# PROJECT: DATA CENTRE SITE ADDRESS: 85 SHARPS ROAD, TULLAMARINE

We understand Request for Further Information (RFI) has been provided by Brimbank City Council and the Department of Transport and Planning (DTP) with respect to the Planning Application for a Data Centre at 85 Sharps Road, Tullamarine.

## Figure 1 Austroads Turn Lane Warrants

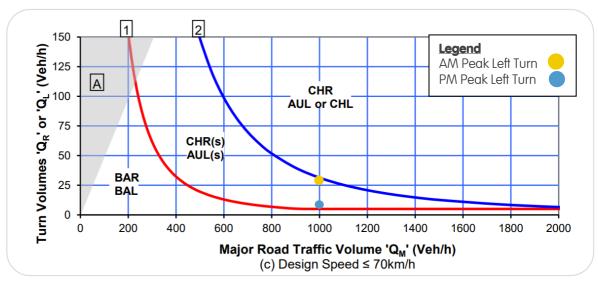
Austroads AGTM06-20 Part 6 Figure 3.25 enables the consideration of a short left turn deceleration on Sharps Road, which has a speed limit of 70km/h. The consultant will need to consider this in their TIAR as if this option is possible, shorter deceleration lanes could be used which would address the following concerns we have with the proposed design:

- The entrance (C1) is too close to the roundabout. This may be confused my motorists seeking to turn left. Consideration of a short deceleration lane as stated in AGTM06-20 Part 6 Figure 3.25 could result in a design where the deceleration lane commences at the same point, however if it is shorter, C1 would be located east of the current location

- Given the unusual configuration of having C3 (exit) immediately before the entry (C2), for this to work, there needs to be some separation between the exit (C3) and the commencement of the deceleration lane (C2). If a shorter deceleration lane is warranted, then this would create the separation between C2 and C3

The warrants for the provision of turn lanes are identified within Section 3.3.6 of the Austroads Guide to Traffic Management Part 6: Intersections, Interchanges and Crossings Management. The Guide determines whether the quantum of turning movements as a function of total through movements on the major road, requires the provision of turn treatments.

Sharps Road has a posted speed limit of 70km/h, the warrants assessment references Figure 3.25 (c). The warrants assessment for each peak period has been undertaken on the basis of the following:

- AM Peak:
  - Left-in volume: 29 movements
  - o Passing / through volume (westbound only): 1,004 movements
- PM Peak:
  - Left-in volume: 8 movements
  - Passing / through volume (westbound only): 1,008 movements

These movements have been plotted on Figure 3.25 (c) as shown in Figure 1

The turn lane warrant assessment determines that during both peak periods, a short auxiliary left turn lane is triggered.

On this basis, the provision of short auxiliary left turn lanes into each proposed access point along Sharps Road can be committed to as part of the application. These provisions can be addressed by way of a Condition of Permit, with the full level of documentation and detail addressed post Permit as part of the preparation of a formal Functional Layout Plan submission to DTP.
